# Work Order ID 105219

Item Name: Crosstube Turning Detail

<b>DART AEROSPACE LTD</b>		<b>Work Order:</b>	105219
<b>Description:</b> Crosstube Assembly (205/212 High Aft)		<b>Part Number:</b>	D212-664-241
<b>Inspection Dwg:</b> D212-664-241 <b>Rev:</b> D		<b>Page 1 of 2</b>

DRAWING NO. D212-664-241	TITLE CROSSTUBE ASSY (205/212 HI AFT)	REV. D	DART AEROSPACE LTD ENGINEERING ORDER		D.E.O. NO. D212-664-241-D-1	SHEET NO. SHEET 1 OF 2	SCALE NTS
DRAWN	CHECKED	MFG. APPR.	APPROVED	DE APPR.			
DATE 11.04.07	DATE 11.04.11	DATE 11.04.12	DATE 11/04/12	DATE 11.04.12

**D212-664-241/-241B  
ASSEMBLY DETAIL**

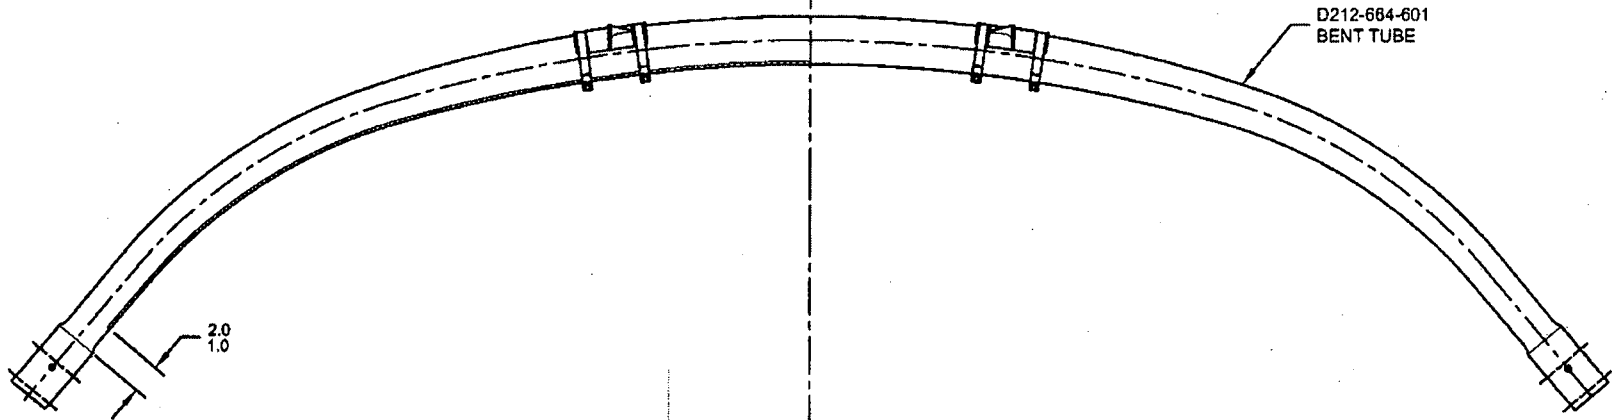
ADD AN INSPECTION WINDOW TO UNDERSIDE OF CROSSTUBE.

NOTES 2 OF SHEET 1 IS AMENDED AS FOLLOWS:

- 2) FINISH: CHEMICAL CONVERSION COAT PER DART QSI 005 4.1  
PRIME INSIDE AND OUTSIDE PER DART QSI 005 4.2  
MASK UNDERSIDE OF CROSSTUBE AS SHOWN (HATCHED AREA) AND  
PAINT OUTSIDE PER DART QSI 005 4.2  
REMOVE MASKING AND APPLY CLEAR COAT

- 2) FINISH: CHEMICAL CONVERSION COAT PER DART QSI 005 4.1  
PRIME INSIDE AND OUTSIDE PER DART QSI 005 4.2  
PAINT OUTSIDE PER DART QSI 005 4.2

MASK AREA PRIOR TO PAINTING,  
REMOVE MASKING AFTER PAINT  
AND APPLY CLEAR COAT
